# 1964 - 1966 Corvette: Service Bulletin: Reverse Lockout Mechanism Revised

**Subject:** Reverse Lockout Mechanism Revised  
**Model and Year:** 1966 Corvette (4-Speed Transmission)  
**Source:** Chevrolet Technical Service Bulletin  
**Bulletin No:** TSB #66-10  
**Section:** VIIb  
**Date:** November 29, 1965

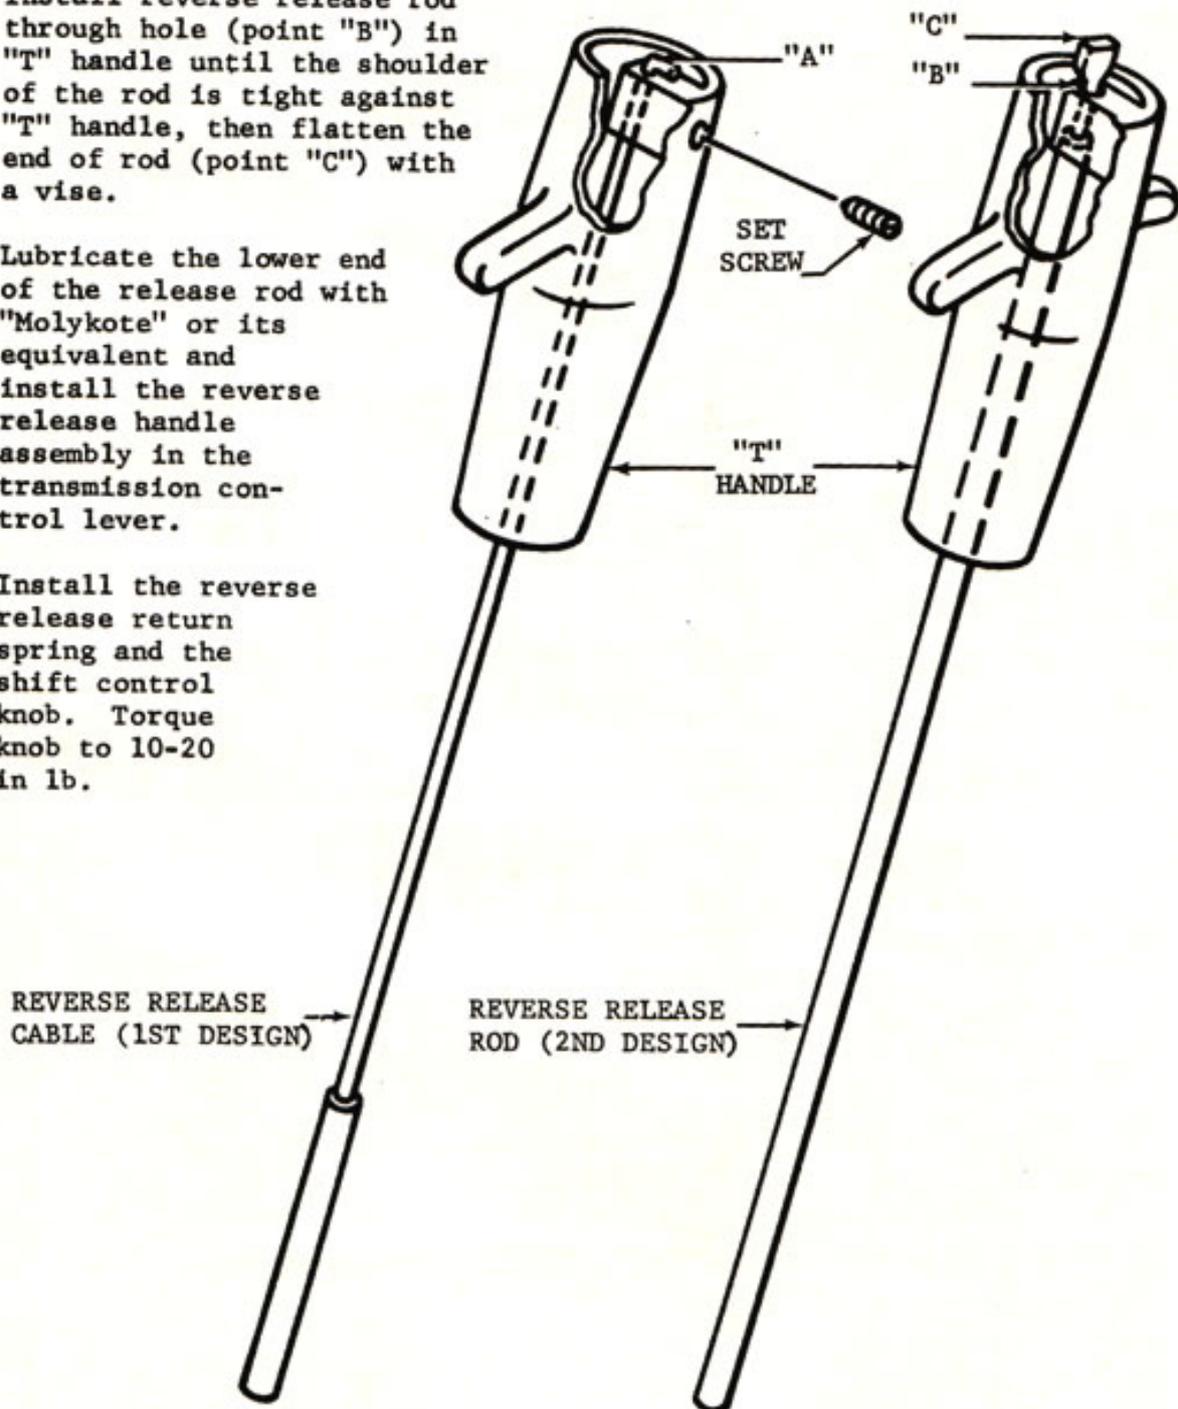
The reverse lockout mechanism for the Corvette 4-speed transmission was revised interim 1966 production. In the early design mechanism, the reverse release cable position is normally controlled by a set screw in the "T" handle. However, should the set screw loosen, this design doesn't insure cable movement with handle movement. Should the cable remain in the up position, accidental selection of reverse gear would be possible.

To eliminate this possibility, the reverse release cable has been replaced by a reverse release rod. The lower diameter of the reverse release rod is larger than the hole in the "T" handle. This larger diameter forms a shoulder and when the "T" handle is released, the rod is forced downward. This design eliminated the set screw and insures the reverse release rod will be lowered whenever the "T" handle is down.

The reverse release rod, Part No. 3889461, may be used in place of the reverse release cable on 1964-65 and early 1966 Corvettes. Instructions for installing the reverse release rod are outlined on page2.

1. Remove the reverse release handle assembly by first removing the shift control knob and the reverse release handle return spring.
2. Straighten the release cable (point "A"), then remove and discard the set screw and reverse release cable.
3. If necessary, enlarge the release cable hole (point "B") in "T" handle to .089"/.093".
4. Install reverse release rod through hole (point "B") in "T" handle until the shoulder of the rod is tight against "T" handle, then flatten the end of rod (point "C") with a vise.
5. Lubricate the lower end of the release rod with "Molykote" or its equivalent and install the reverse release handle assembly in the transmission control lever.
6. Install the reverse release return spring and the shift control knob. Torque knob to 10-20 in lb.
